| Project | IEEE 802.16 Broadband Wireless Access Working Group < http://ieee802.org/16 > |
| Title | Amendment to Subscriber Mode Management in Section 14.2.6 |
| Re: | Call for Comment on P802.16g Baseline Document |

Amendment to Subscriber Mode Management in Section 14.2.6

Figure 493 Subscriber mode transition diagrams of MS & BS

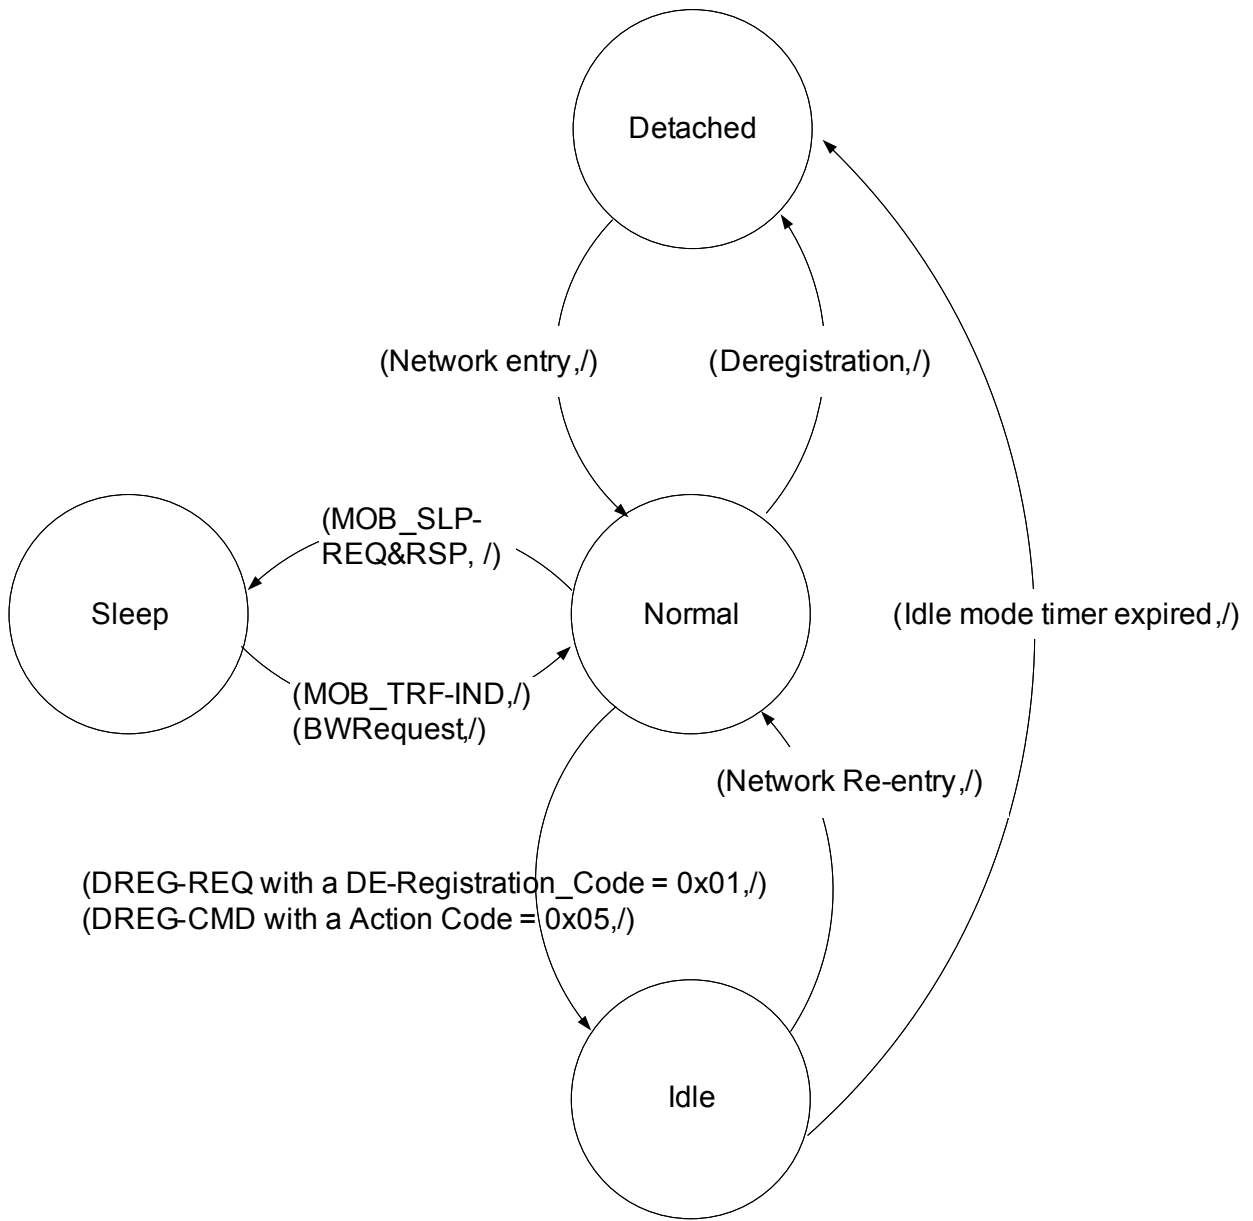
In Section 14.2.6, subscriber mode management is described, where subscriber mode consists of Normal Mode, Idle Mode, and Sleep Mode. The current subscriber mode management, however, only deals with modes when an MS is attached to a BS after initial network entry. Thus, the subscriber mode transition diagrams at MS, BS, and NCMS start from Normal Mode. However, we think that the subscriber mode should include a new mode, called Detached Mode, where an MS is not attached to a BS, and the subscriber mode transition diagrams should start from the detached mode, as many other mobile systems do. In this contribution, we define Detached Mode and modify the subscriber mode transition diagrams accordingly.

Figure 493 shows Subscriber Mode transition diagram at both an MS and a BS. Initially, the subscriber mode is Detached Mode and the subscriber mode at both an MS and a BS changes from Detached Mode to Normal Mode after initial network entry procedure. Subscriber Mode ~~at both an MS and a BS~~ changes from Normal ~~Operation Mode~~ to Idle Mode when the MS issues an MS De-registration Request (DREG-REQ) message with De-Registration_Request_Code=0x01 or the BS issues an De-register Command (DREG-CMD) message with Action Code = 0x05. Then, the MS stays at Idle Mode and updates its location when the paging group changes. The Subscriber Mode returns back to Normal ~~Operation Mode~~ from Idle Mode after completing ~~n~~Network re-entry. Transition from Normal ~~Operation Mode~~ to Sleep Mode is performed after an MS successfully exchanges Sleep Request (MOB_SLP-REQ) and Sleep Response (MOB_SLP-RSP) messages with a BS. If there is any DL traffic toward an MS from a BS, MOB_TRF-IND is broadcast to the MS from the BS and Subscriber Mode of the MS and the BS changes from Sleep Mode to Normal ~~Operation Mode~~. If there is any UL traffic from an MS, Bandwidth Request (BW Request) is sent to the serving BS from the MS and Subscriber Mode of the MS and the BS changes from Sleep Mode to Normal ~~Operation~~, too. Transition to Detached Mode from Normal Mode occurs when the MS sends DREG-REQ message without Deregistration_Code=0x01 or receive DREG-CMD without Action Code = 0x05. Transition to Detached Mode from Idle Mode ~~occurs~~ occurs when the Idle Mode Timer of the MS is expired.

Editorial note: IP address release not addressed yet when transitioning from Idle Mode directly to Detached Mode.

If MS is switched off in any of Normal, Idle, and Sleep Modes, the state moves to Detached Mode.

Editorial note: IP address release not addressed yet.

Figure 494 Subscriber mode transition diagrams of NCMS

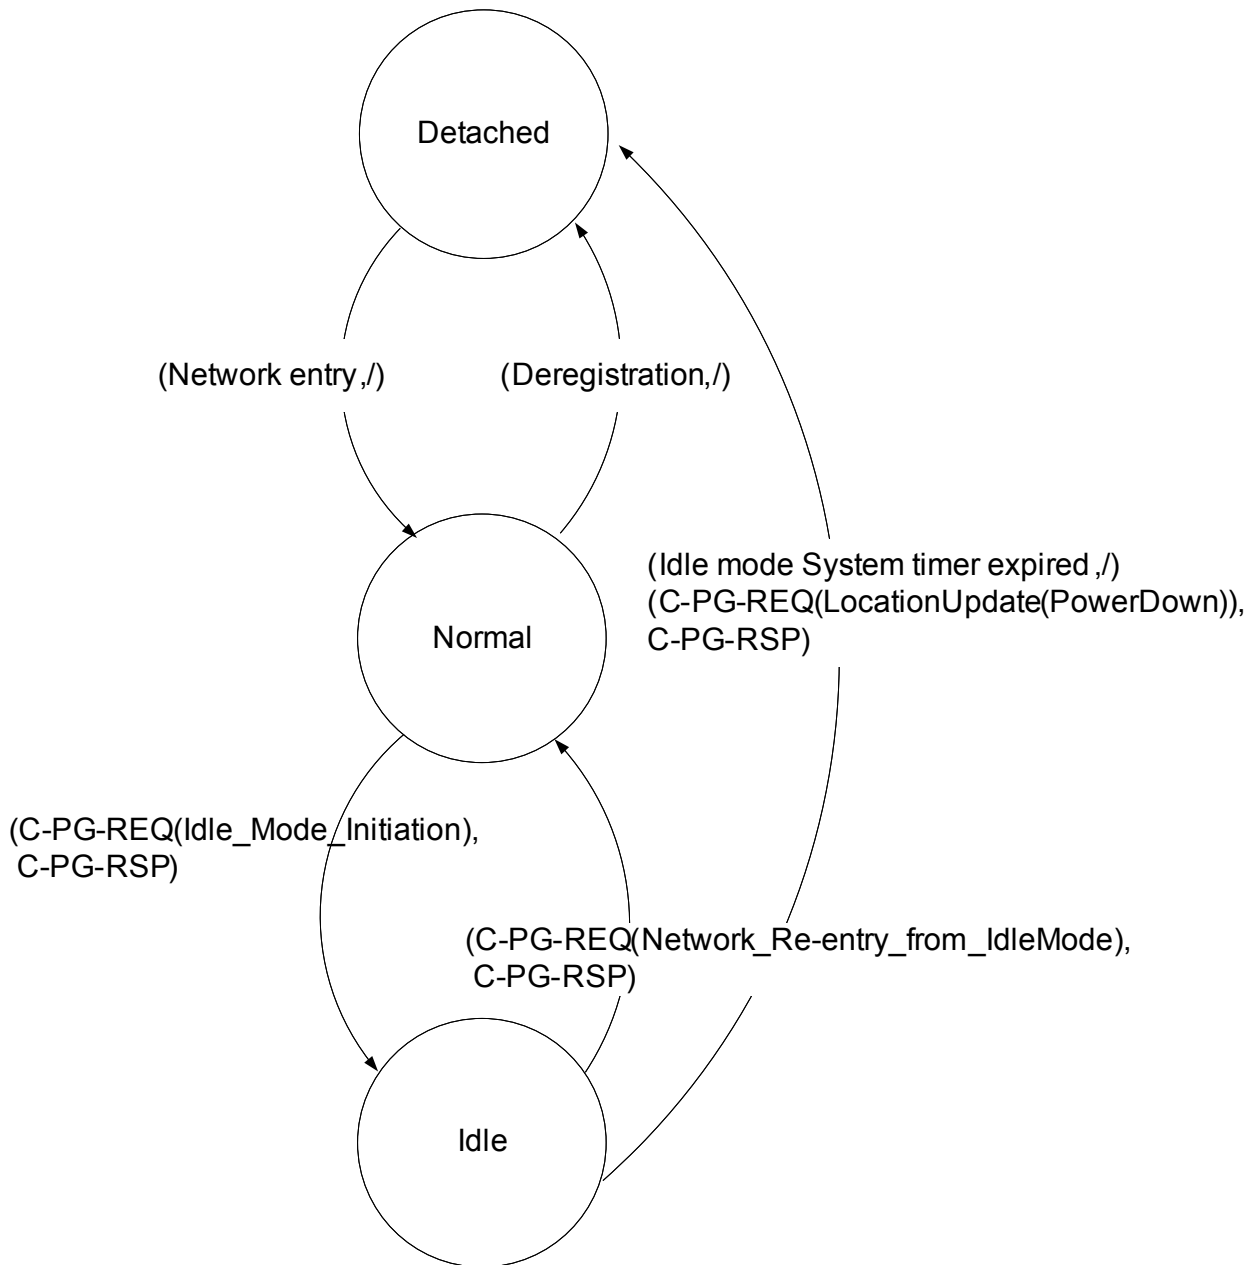
Figure 494 shows Subscriber Mode transition diagram at the NCMS with service primitives related with the Subscriber Mode transition. Initially, the subscriber mode is Detached Mode and the subscriber mode at NCMS changes from Detached Mode to Normal Mode after initial network entry procedure of MS. Subscriber Mode transition from Normal ~~Operation Mode~~ to Idle Mode is performed by exchanging C-PG-REQ and C-PG-RSP between a BS and the NCMS after successful DREG-REQ message with De-Registration_Request_Code=0x01 or DREG-CMD message with Action Code = 0x05 between an MS and a BS, where C-PG-REQ and C-PG-RSP are defined in 14.2.6.2.1 and 14.2.6.2.2, respectively. Subscriber Mode transition from Idle Mode to Normal ~~Operation Mode~~ is initiated after exchanging C-PGNOTFY, C-PG-RSP, and C-PG-ACK between a BS and the NCMS, where C-PG-NOTFY, C-PG-RSP, and C-PG-ACK are defined in 14.2.6.2.4, 14.2.6.2.2, and 14.2.6.2.3, respectively. Transition to Detached Mode from Normal Mode occurs by exchanging C-PG-REQ and C-PG-RSP between a BS and the NCMS after successful DREG-REQ message without De-Registration_Request_Code=0x01 or DREG-CMD message without Action Code = 0x05 between an MS and a BS. Transition to Detached Mode from Idle Mode occurs when the Idle Mode System Timer is expired. If MS is switched off in either Normal or Idle Mode, the state moves to Detached Mode.
